SUBJECT: NORTH ANNA POWER STATION, UNITS 1 AND 2 – STAFF ASSESSMENT OF  
RESPONSE TO 10 CFR 50.54(f) INFORMATION REQUEST – FLOOD-  
CAUSING MECHANISM REEVALUATION (TAC NOS. MF1106 AND MF1107)

STAFF ASSESSMENT BY THE OFFICE OF NUCLEAR REACTOR REGULATION

RELATED TO FLOODING HAZARD REEVALUATION REPORT

NORTH ANNA POWER STATION, UNITS 1 AND 2

**Figure 3.1-3. HEC-HMS Drainage Subbasin Model and HEC-RAS Flowpaths for Protected Area, Including the West Basin**

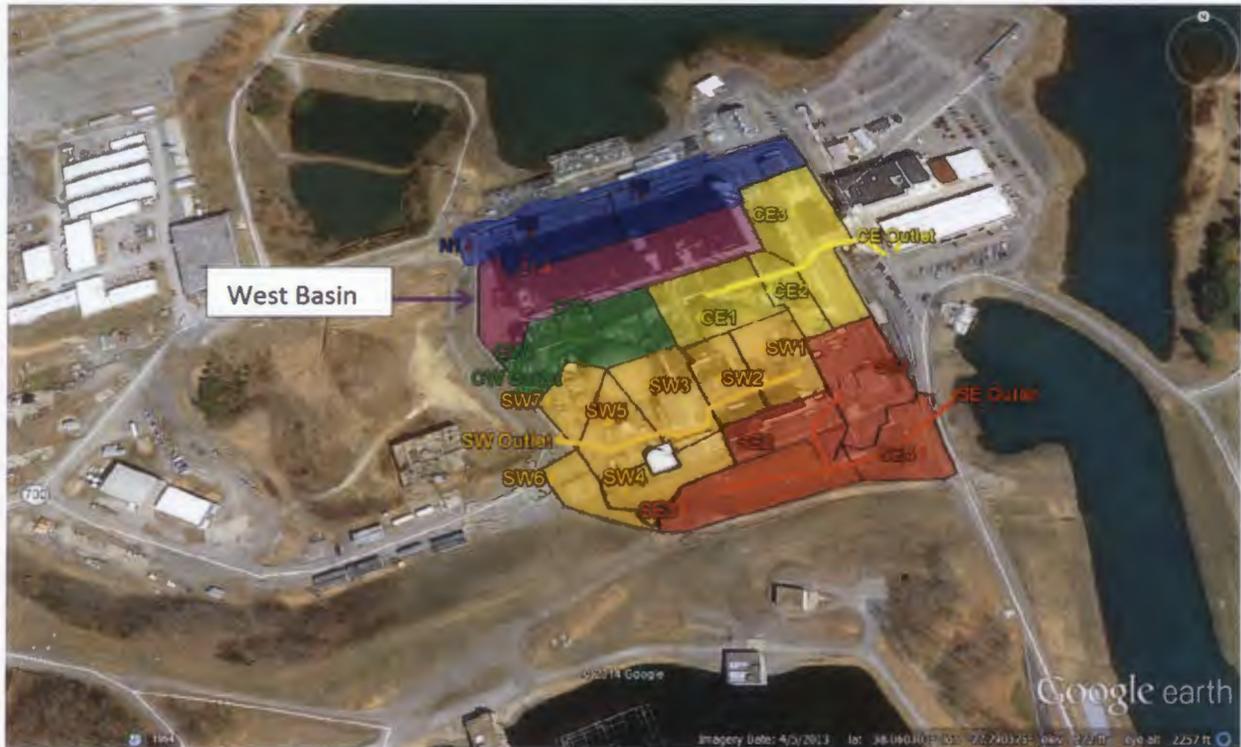
The NRC staff focused its review on the modeling of Subbasin-CW1 (e.g., upper central west subbasin in the powerblock area as shown in Figure 3.1-3), because the maximum LIP flood level occurs on this subbasin. This subbasin covers half of the Control Building, half of the Unit 2 Reactor, and the open grade area between these two buildings (marked in green in Figure 3.1-3). The Turbine Building is attached to the north side of the Control Building, and the elevation of the Turbine Building roof is higher than that of the Control Building roof. In its review of the FHRR and RAI response, the staff raised to the licensee a question that a portion of the runoff from the Turbine Building roof could flow to the Subbasin-CW1 if there were drain holes on the south side of the Turbine Building roof. The licensee confirmed that there are no roof drain holes on the south side of the Turbine Building roof, resolving the staff's question related to the Turbine Building roof runoff (Shaub, 2014).

**Figure 3.2-1. Area West of Plant, Including Subbasin U3**

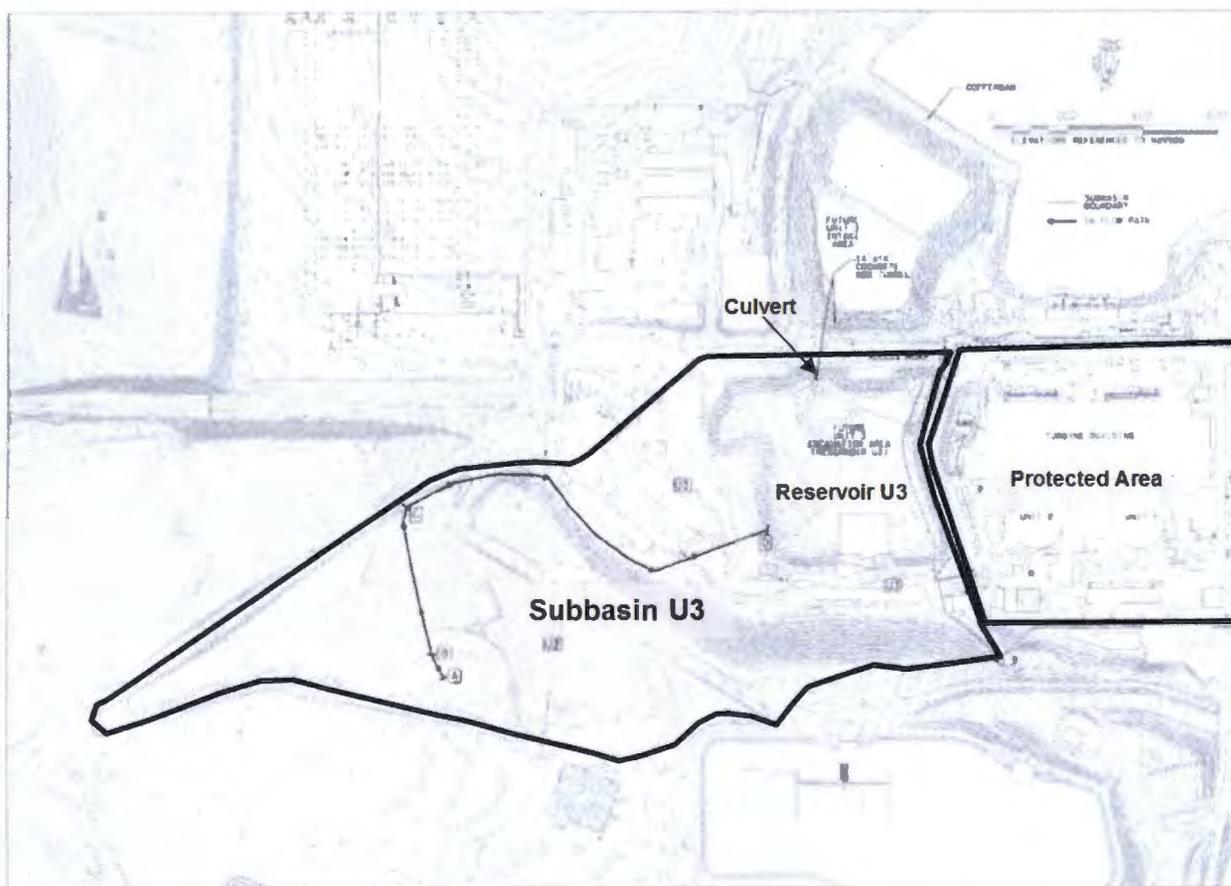
The node labeled “Reservoir-U3” in the HEC-HMS simulation represents the large excavated area for the proposed Unit 3 located west of the Protected Area (Figure 3.2-1). This surface depression can drain directly to Lake Anna via a 14 ft (4.3 m) × 14 ft (4.3 m) culvert. Two flowpaths, from the Protected Area and Subbasin U3, drain into Reservoir-U3. The FHRR provided stage-area and stage-discharge relationships for Reservoir-U3. To build the stage-discharge relationship, the licensee assumed that the lower half of the culvert is blocked with debris and that the exit of the culvert is submerged by Lake Anna at 265 ft (80.8 m) NGVD29.

**Figure 3.4-1. Location of Postulated Dike Breaches on the Service Water Reservoir and Emergency Dike (Top), and Cross Section Profile (Bottom)**

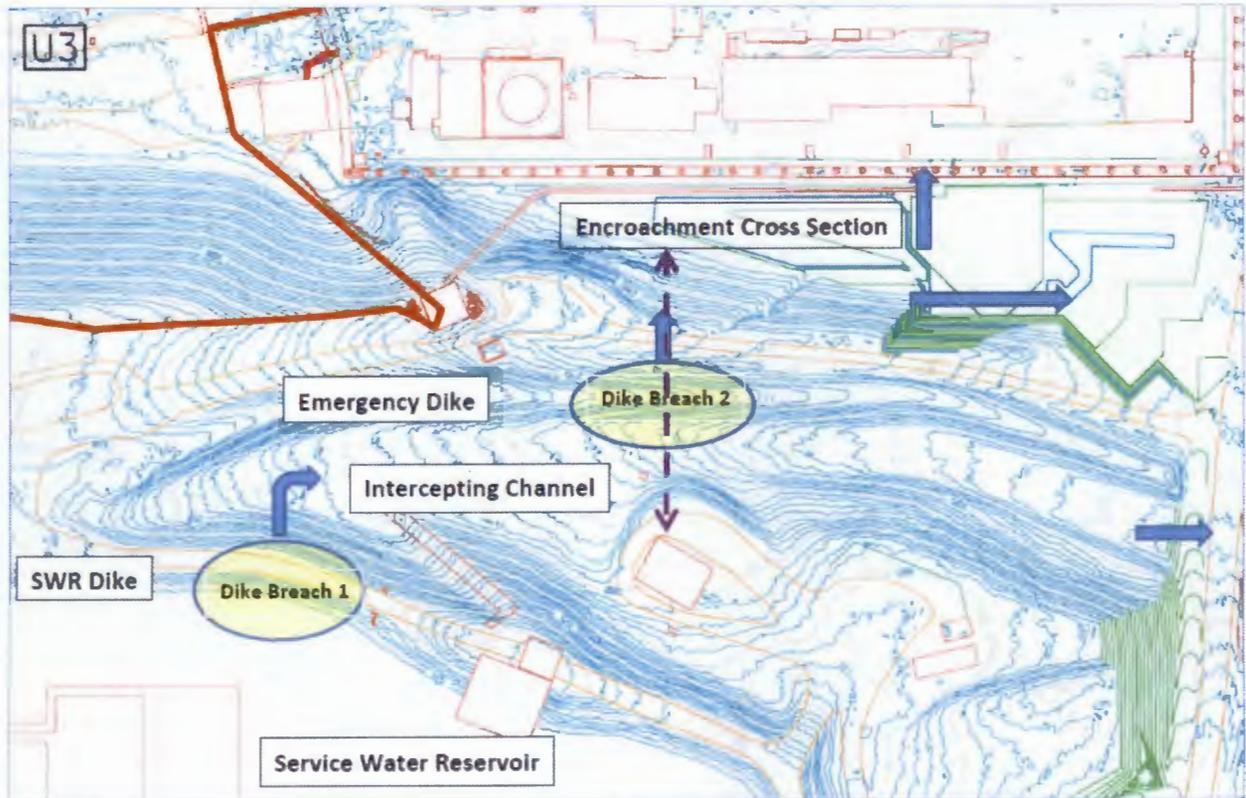
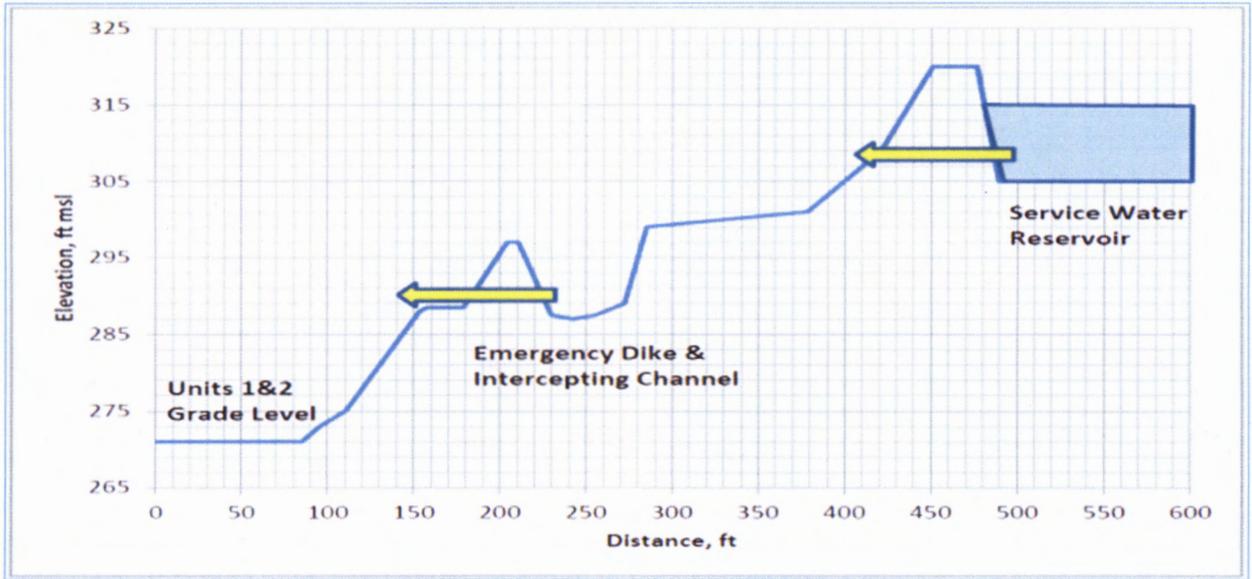
Discharge Canal. The Intercepting Channel has a nominal width of about 35 ft (11 m) and a total length of approximately 800 ft (240 m). The Emergency Dike forms the left bank of the channel with an average height of about 10 ft (see Figure 3.4-1).

- A dike breach would occur on the northern section of the Impounding Dike between the Pump House and the junction of the Impounding Dike and the Emergency Dike (Figure 3.4-1, Dike Breach 1). A breach only on this critical section could potentially impact the Units 1 and 2 powerblock area. In other words, a breach flood occurring from outside this critical section will not impact the plant site.
- The NRC staff selected the encroachment section of the Intercepting Channel (Figure 3.4-1, Dike Breach 2) as a potential location for overtopping or piping failure of the Emergency Dike. This is because the velocity and head of the channel flow on this section could potentially increase due to the encroachment effects, resulting in overtopping and breaching of the Emergency Dike.
